**RX** Family

R20TS0595EJ0100 Rev.1.00 Jul. 01, 2020

# CAN API Firmware Integration Technology,

# **RX Driver Package**

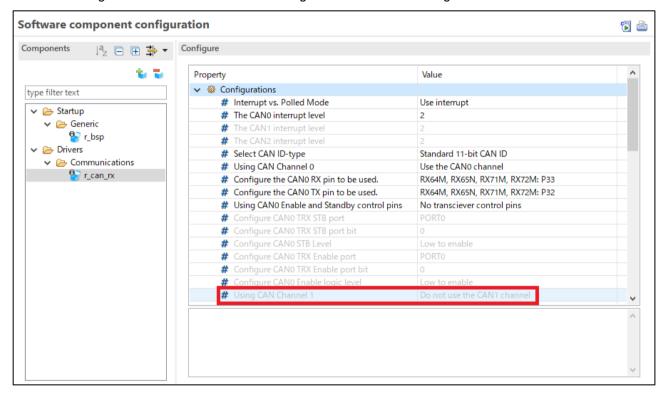
CAN Channel 1 cannot be configured by using the Smart Configurator.

Value for 'Using CAN Channel 1' cannot be changed as shown in the image below.

Add the processing shown in red to r\_can\_rx\_vX.XX.mdf (Note1) in the CAN FIT module.
